Low Temp Test procedure for EVs

Revised ACEA EV proposal taking discussions and feedback of SG EV meeting on February 13th and JPN proposal into account

Status: 18.02.2020

Proposal for -7°C Procedure – Base procedure with no customer preconditioning action

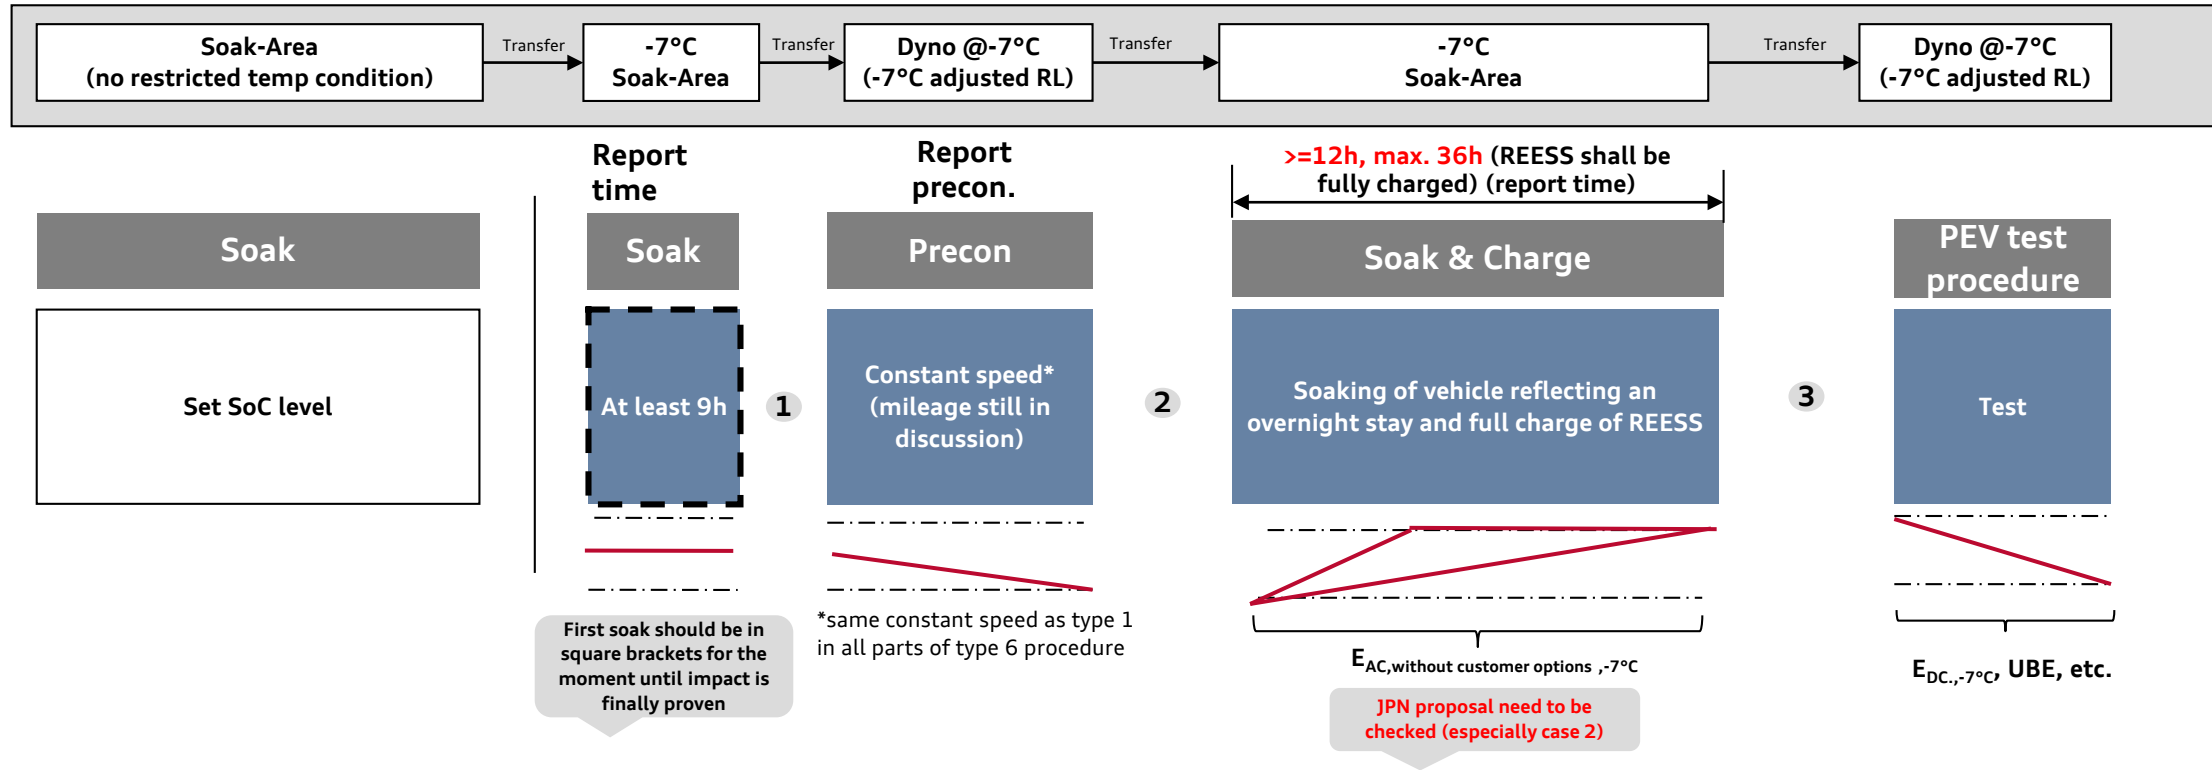
Proposal ACEA TF EV (revised version based on SG EV meeting on February 13th):

- 1 Leaving soak (-7°C) until starting PreCon test in test cell (-7/23°C): max.: [40] min (transfer: max. [20] min, preparation on dyno: max. [20] min)
→ Without any unjustified delay
- 2 End test cycle (-7°C) and placing in soak (-7°C): max.: [30] min where max. [20] min for transfer
→ without any unjustified delay, connecting to grid within max. [30] min
- 3 Leaving soak (-7°C) until starting test in test cell (-7/23°C): max.: [40] min (transfer: max. [20] min, preparation on dyno: max. [20] min)
→ Without any unjustified delay; vehicle shall not receive unjustified exposure to temperatures higher than -7°C; in case that is unavoidable, this shall not be longer than [20] min
→ Note: only max. [30] min between different tests on the dyno shall not be exceeded (only related to dyno warm-up)

Proposal for -7°C Procedure – Base procedure with no customer based preconditioning action

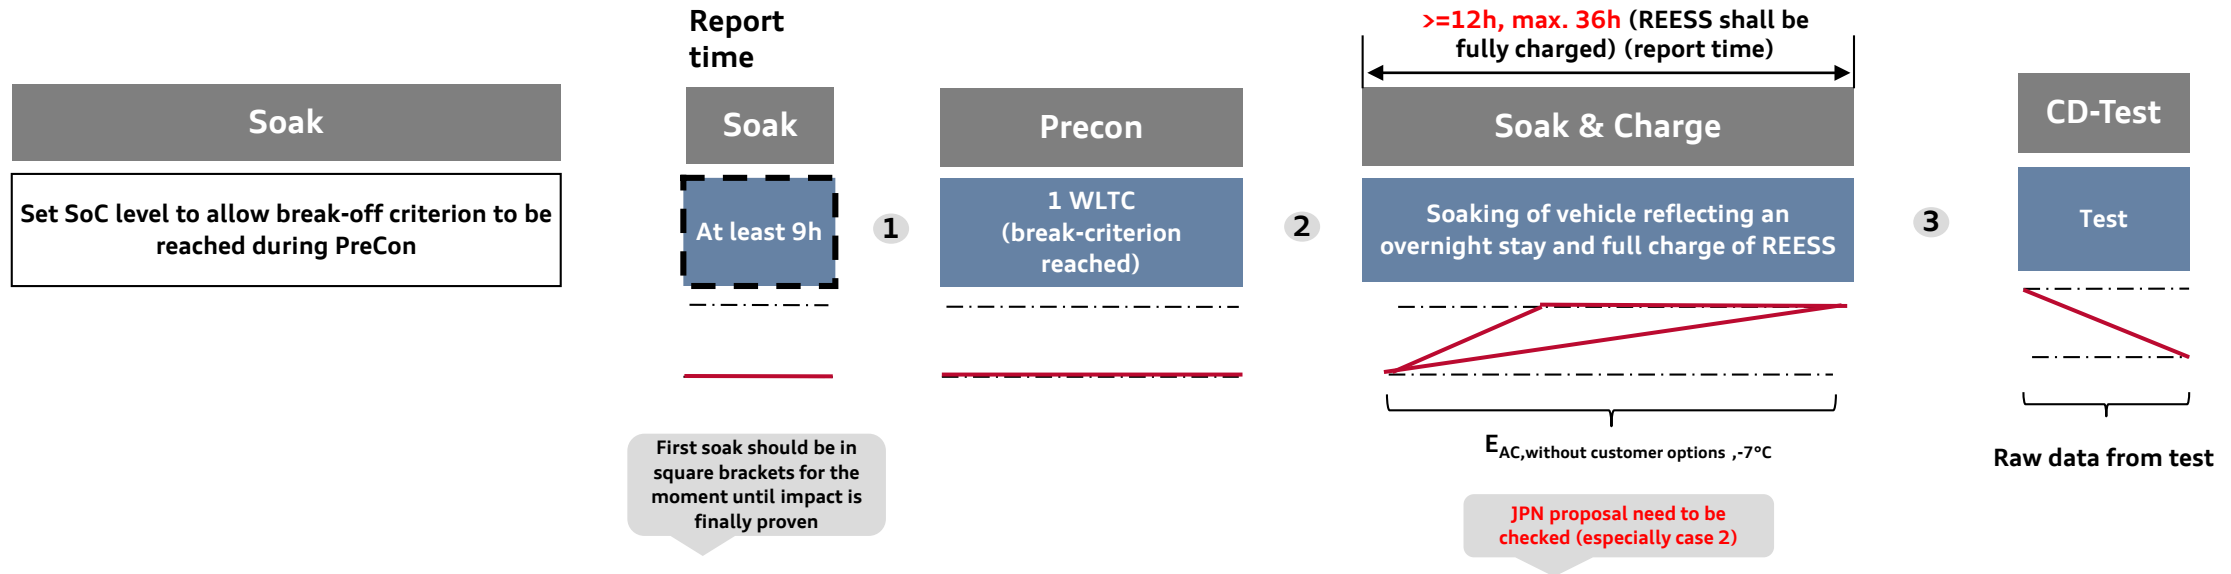
Proposal ACEA TF EV (revised version based on SG EV meeting on February 13th):

- 1** Leaving soak (-7°C) until starting PreCon test in test cell (-7/23°C): max.: [40] min (transfer: max. [20] min, preparation on dyno: max. [20] min)
→ Without any unjustified delay
- 2** End test cycle (-7°C) and placing in soak (-7°C): max.: [30] min where max. [20] min for transfer
→ without any unjustified delay, connecting to grid within max. [30] min
- 3** Leaving soak (-7°C) until starting test in test cell (-7/23°C): max.: [40] min (transfer: max. [20] min, preparation on dyno: max. [20] min)
→ Without any unjustified delay; vehicle shall not receive unjustified exposure to temperatures higher than -7°C; in case that is unavoidable, this shall not be longer than [20] min
→ Note: only max. [30] min between different tests on the dyno shall not be exceeded (only related to dyno warm-up)

Proposal for -7°C Procedure

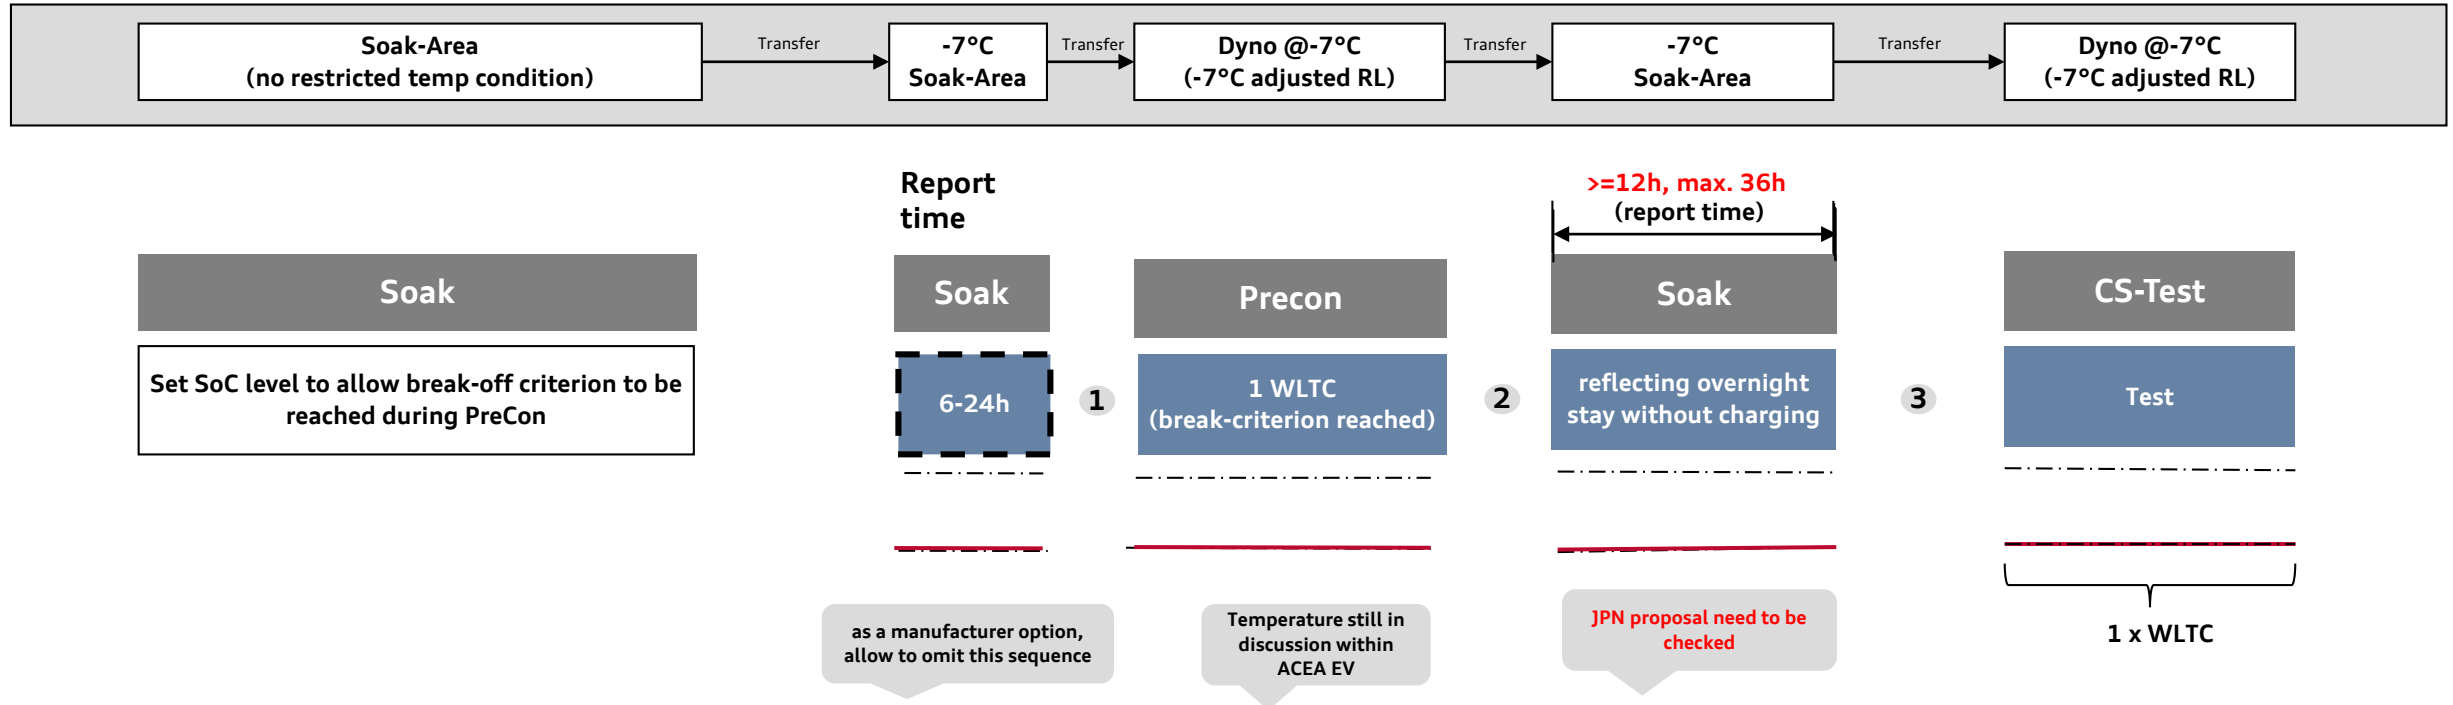
ACEA proposal Charge-Sustaining Test (revised version based on SG EV meeting on February 13th):

- 1 Leaving soak (-7°C) until starting PreCon test in test cell (-7/23°C): max.: [40] min (transfer: max. [20] min, preparation on dyno: max. [20] min)
→ Without any unjustified delay
- 2 End test cycle (-7°C) and placing in soak (-7°C): max.: [30] min where max. [20] min for transfer
→ without any unjustified delay
- 3 Leaving soak (-7°C) until starting test in test cell (-7/23°C): max.: [40] min (transfer: max. [20] min, preparation on dyno: max. [20] min)
→ Without any unjustified delay; vehicle shall not receive unjustified exposure to temperatures higher than -7°C; in case that is unavoidable, this shall not be longer than [20] min
→ Note: only max. [30] min between different tests on the dyno shall not be exceeded (only related to dyno warm-up)
